Castro Mission Health Center Seismic Upgrade

Amendments to Approved CDR Phase 2 Design Following Input by Historic Preservation

July 17th 2018

Structural Upgrade Overview

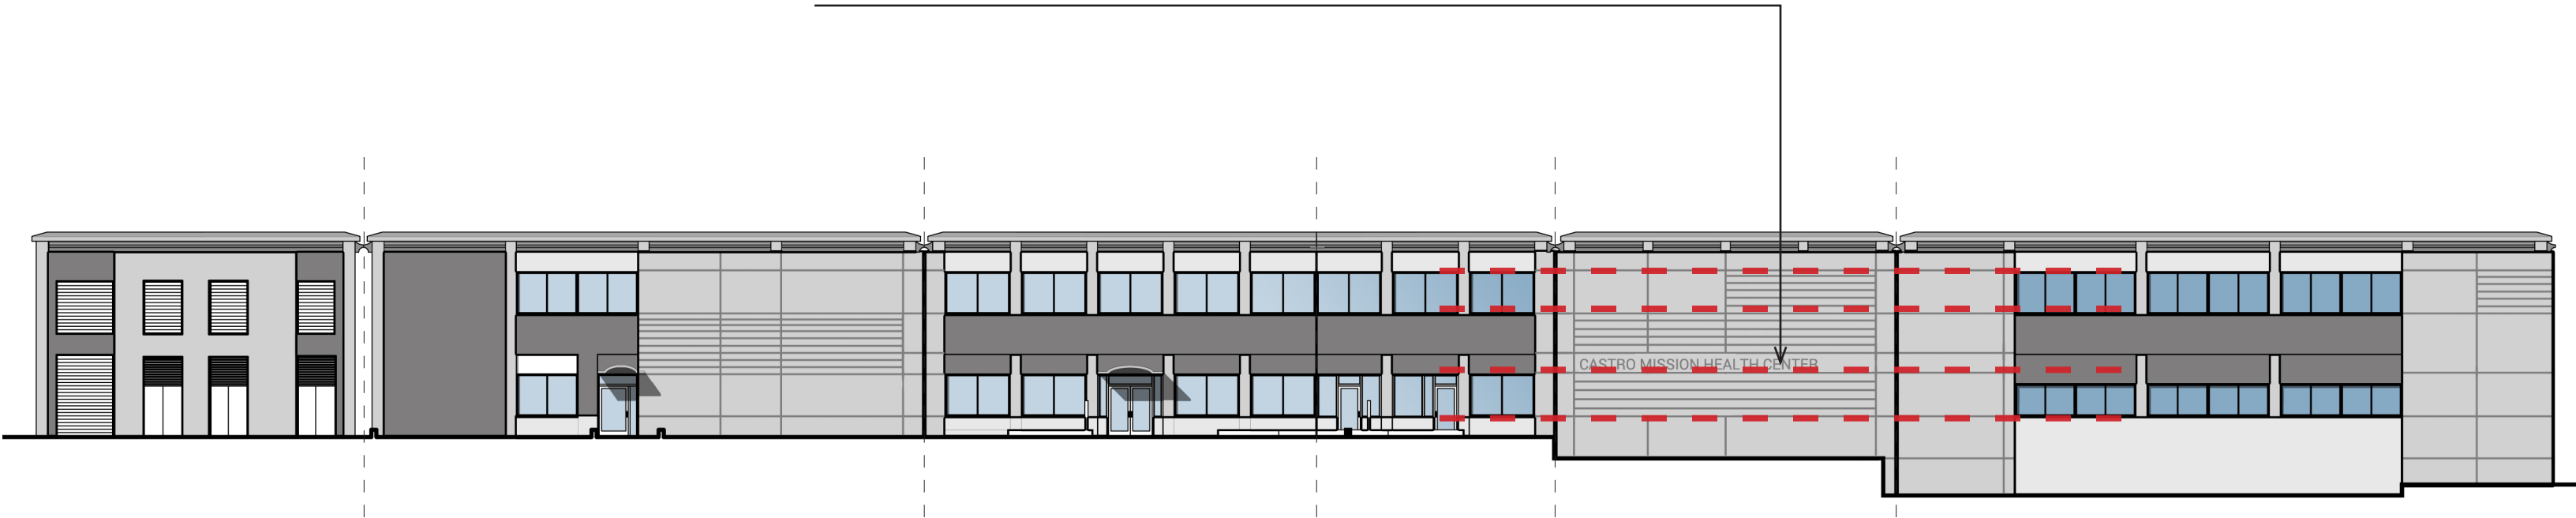
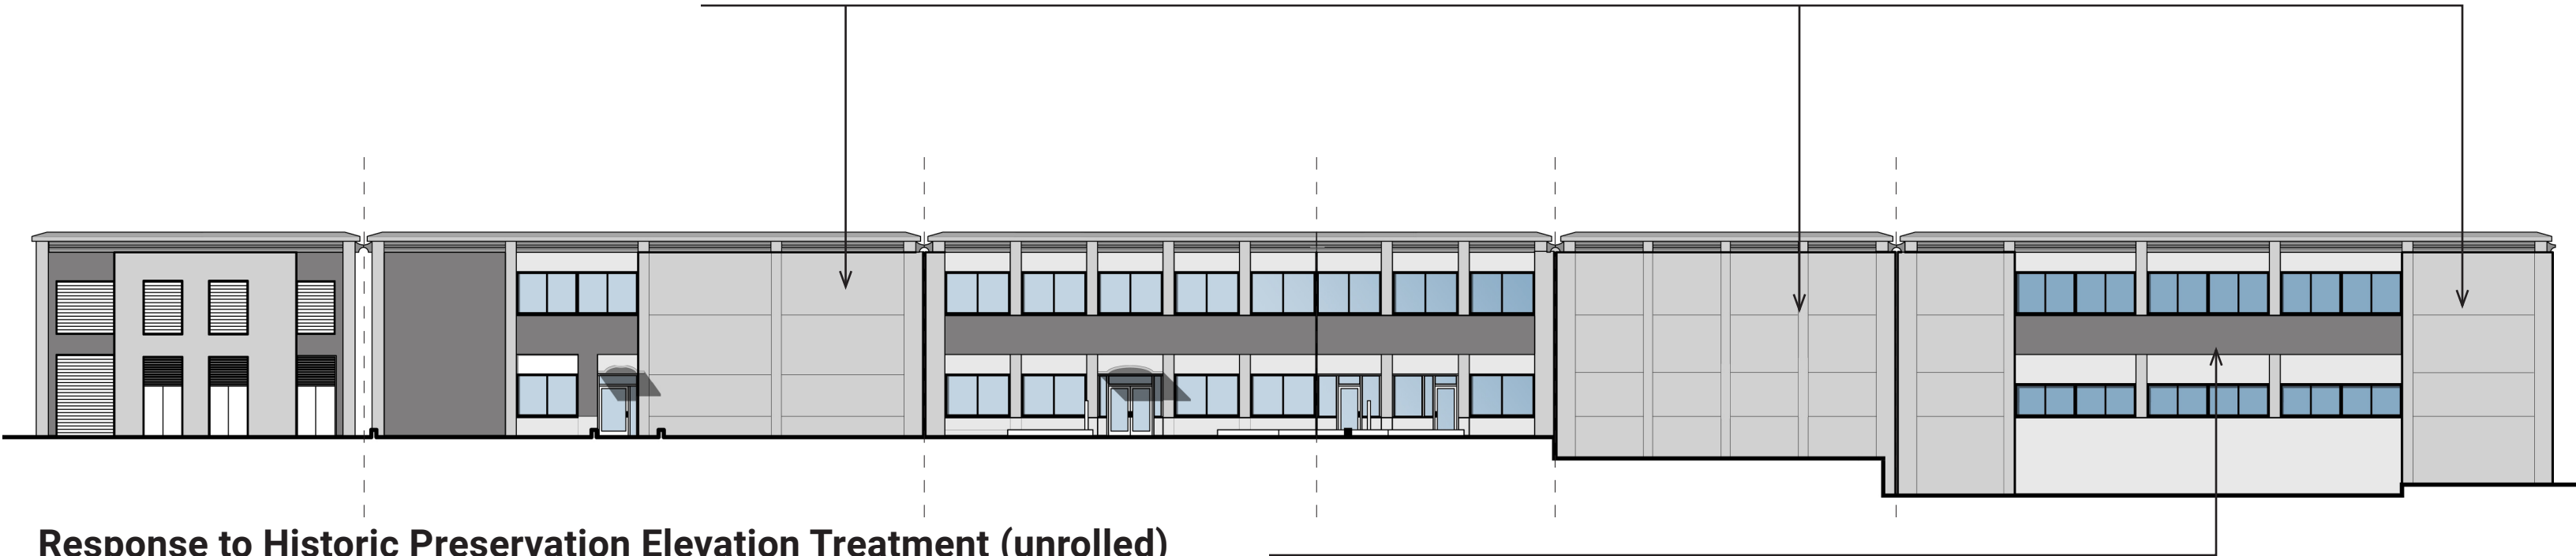
In place of the more subtle and streamlined shear walls, the design in response to the comments from historic preservation entails the recreation of the existing pilasters in the new shear walls, mimicing both the width and depth of the existing. Horizontal control joints are fewer in number, but still align with the window sill and head datum.

Hatch indicates areas where shear walls are extended for consistency of appearance rather than strict structural necessity.

The design intent of the previously proposed elevation treatment is to emphasize the horizontality of the existing facade in the new shear walls.

A response to historic preservation recreates the pilasters in front of the new shear walls. Horizontal control joints mimic the existing banding of the building.

Response to Historic Preservation Elevation Treatment (unrolled)

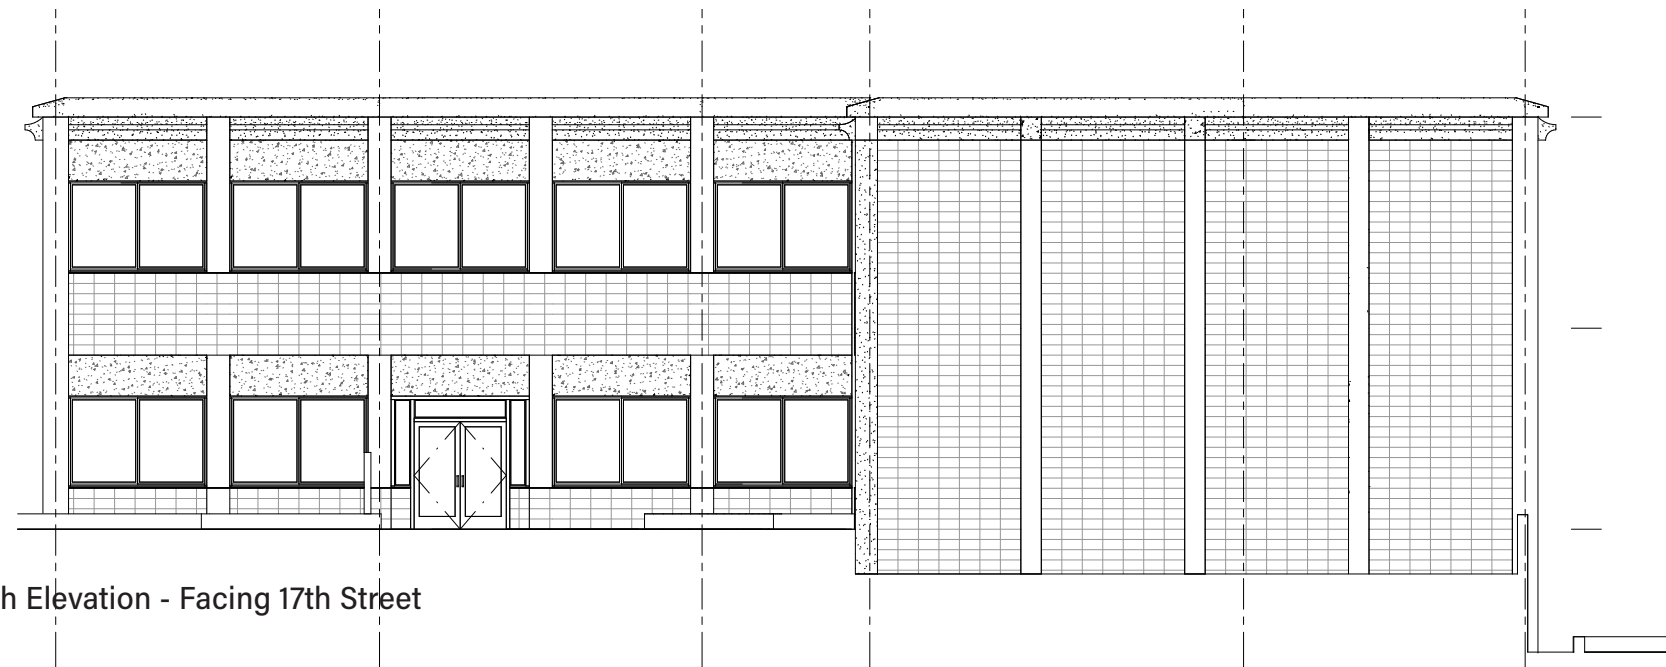
The remainder of the facade, excepting the glazed areas, are to be cleaned, painted, and/or covered with a cement plaster to echo the appearance of the new shear walls.

Elevation Comparison

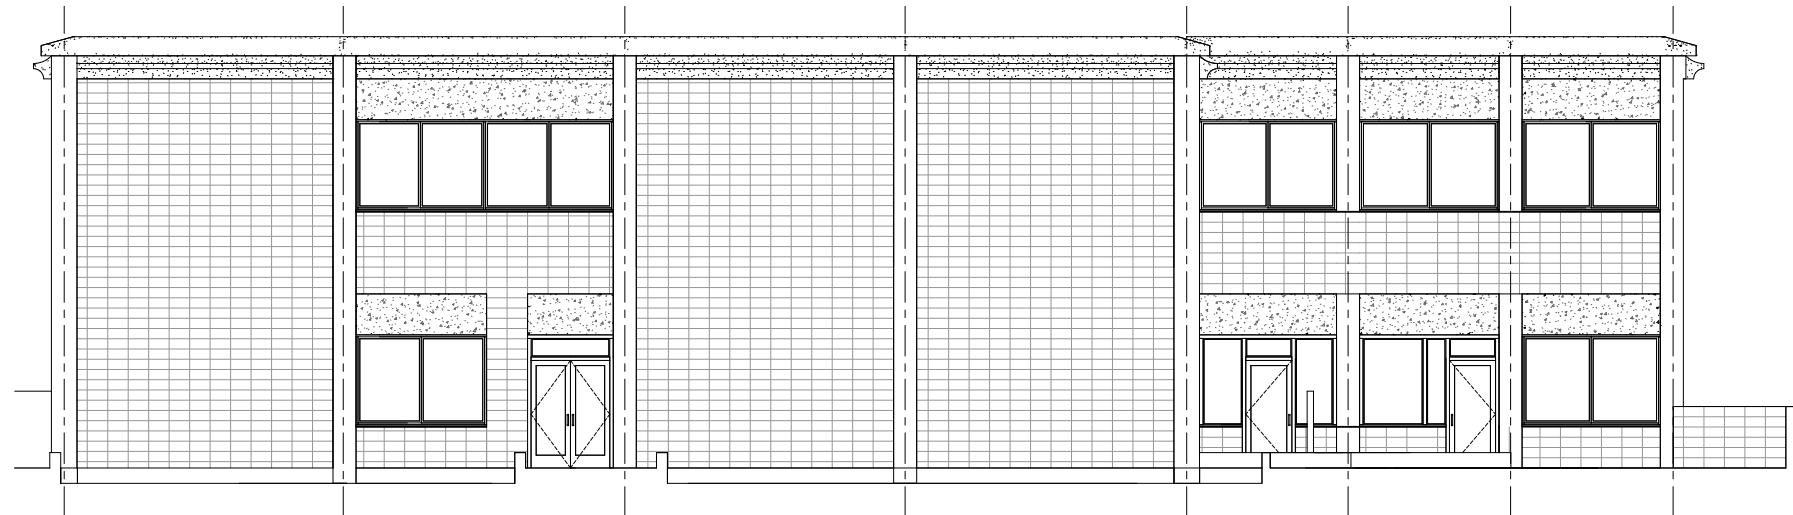
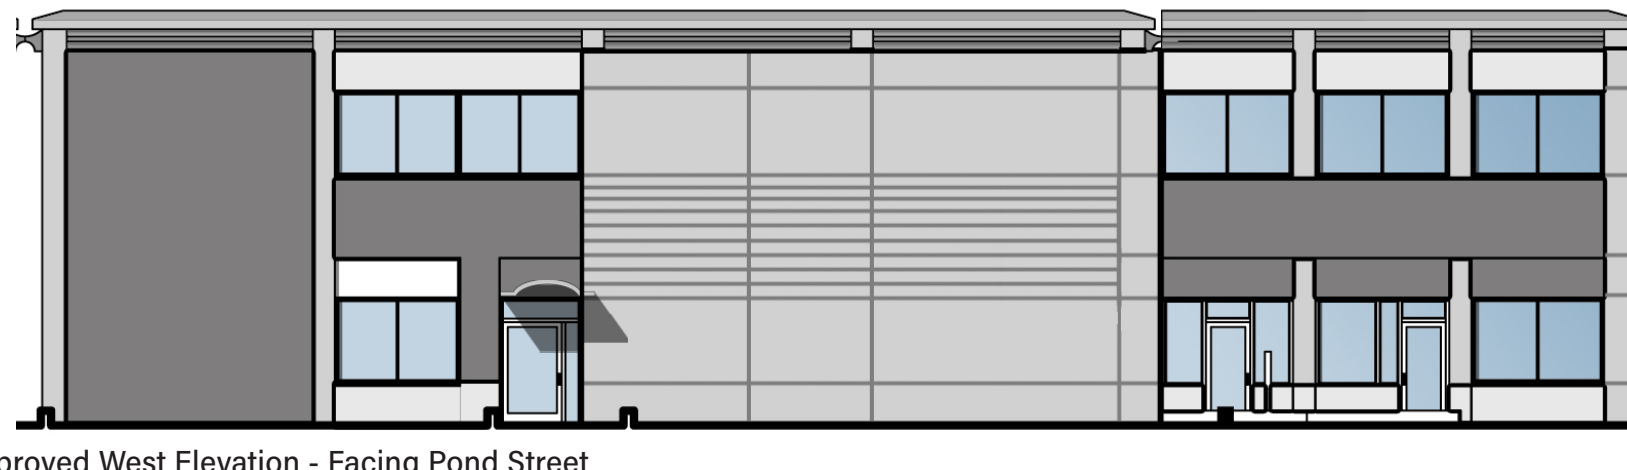
CDR Phase 2 Approved South Elevation - Facing 17th Street

Response to Historic Preservation South Elevation - Facing 17th Street

Plan Detail

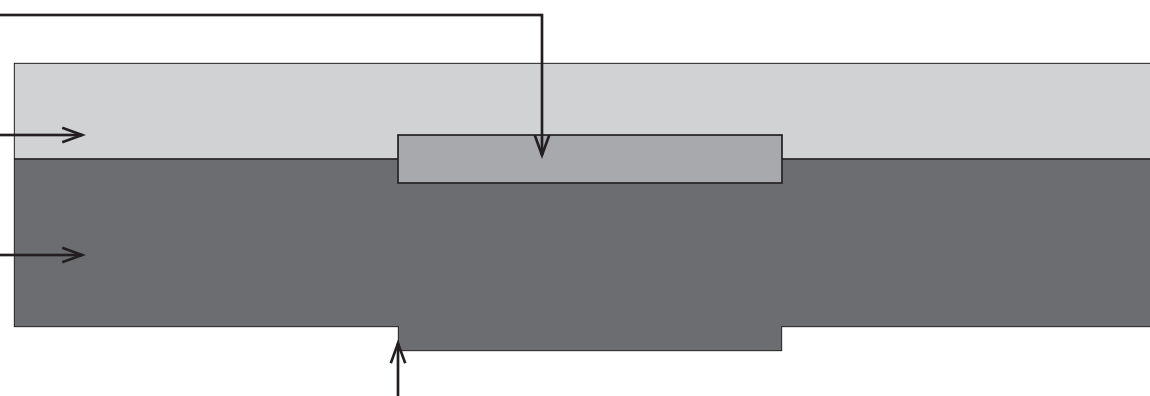
New pilasters project 2" from face of new shear wall. This matches the projection of the current pilasters from the face of the existing CMU.

New pilasters project 2" from face of new shear wall. This matches the projection of the current pilasters from the face of the existing CMU.

Cornice Detail in Response to Historic Preservation Comments

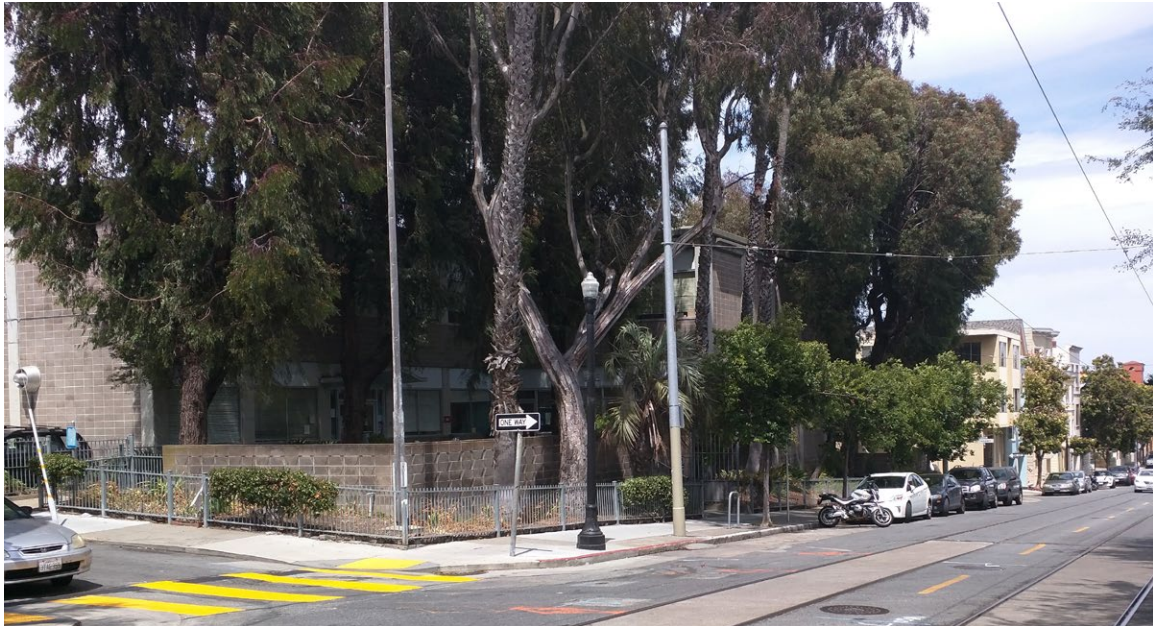
CDR Phase 2 Approved Design

Response to Historic Preservation
